REZONING APPLICATION

Specific Implementation Plan

Artisan Village - Specific Implementation Plan Overview

SHEET NUMBER:
C3.1

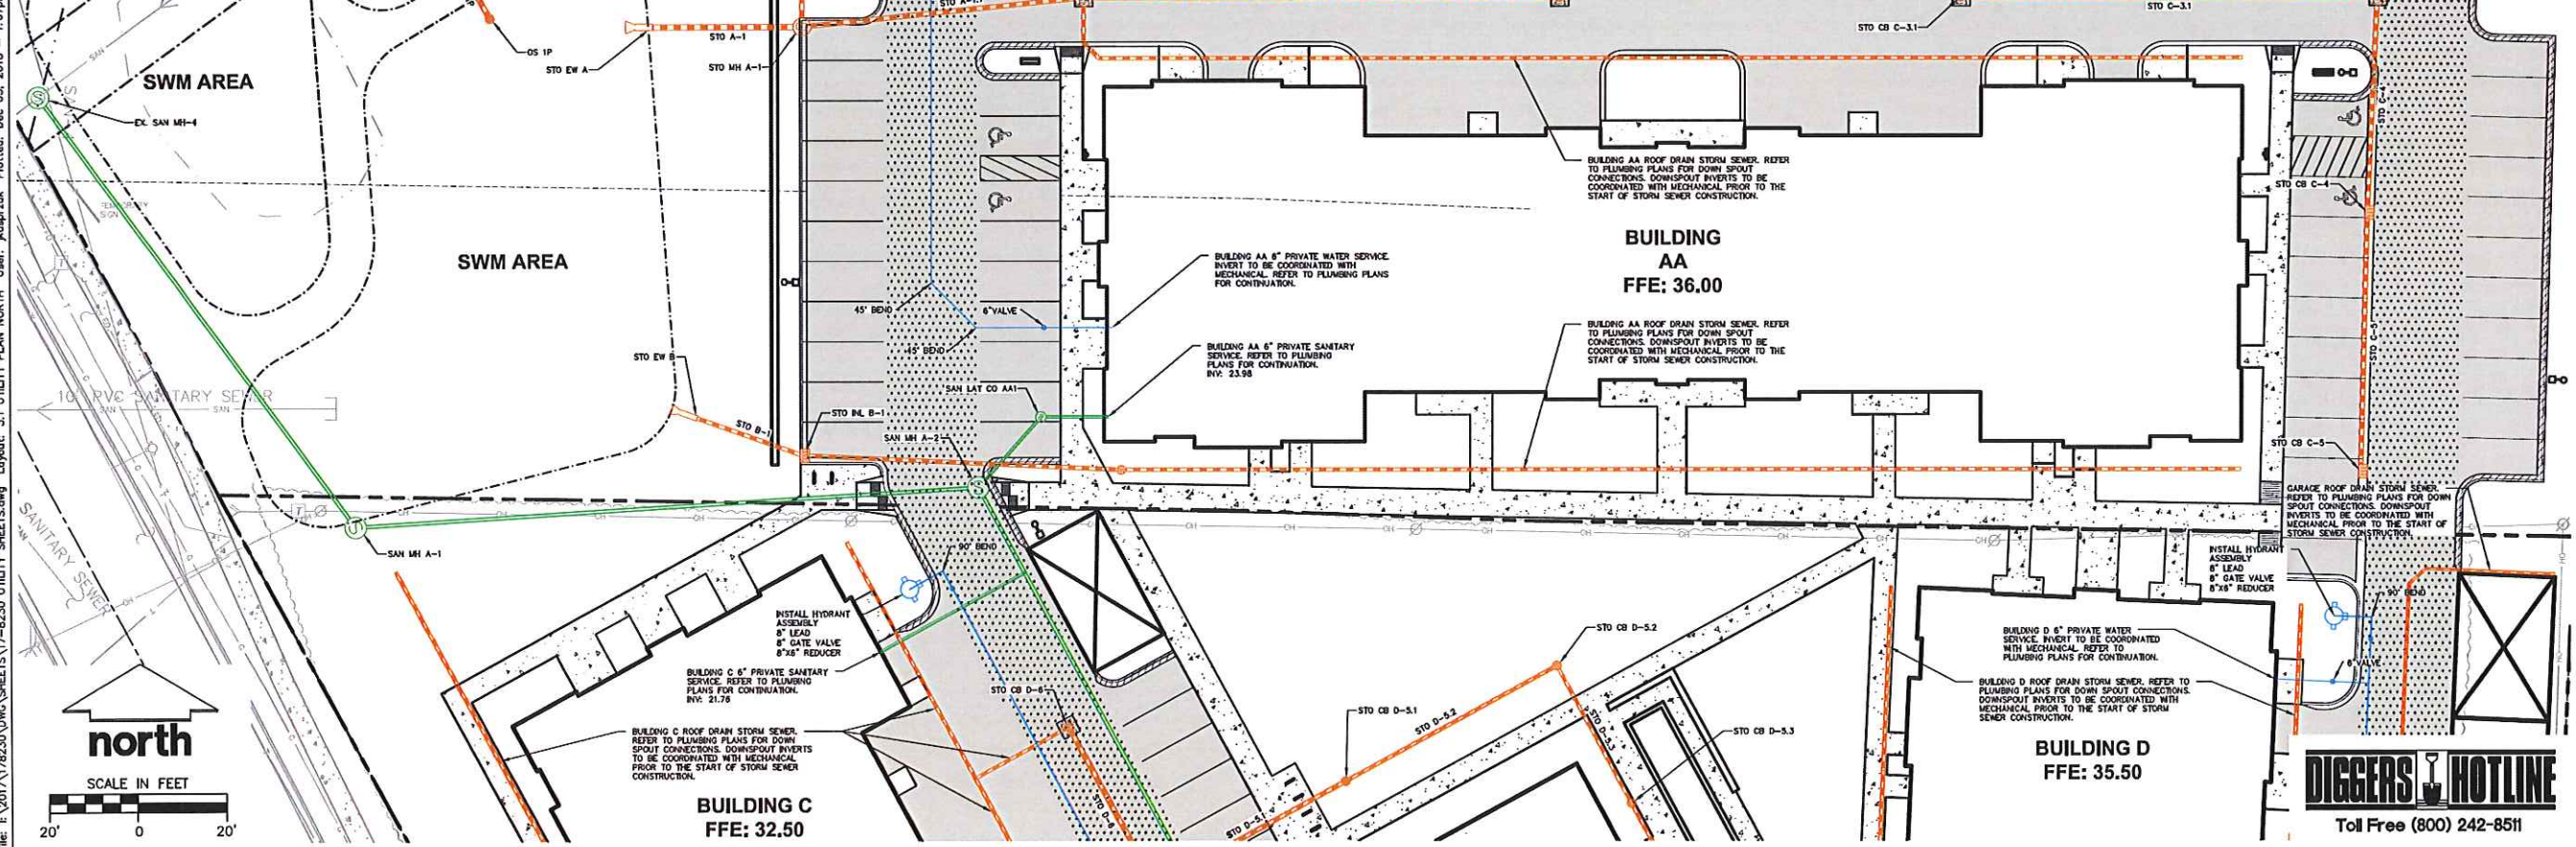
4. The private water main on sheet C3.1 shall end with two 45 degree bends an 8" gate valve, an 8"x6" reducer and a hydrant. The water main between the north and south lots will not be connected in the future.

Response: Private water mains on C3.1 have been revised to no longer have tees that are capped and sealed. The service entering building AA has been revised to two 45 degree bends prior to entering the building. The Hydrant next to building C has been revised to have a 90 degree bend, 8" gate valve and an 8"x6" reducer. There is not enough space to construct two 45 degree bends prior to the hydrant assembly in this location.
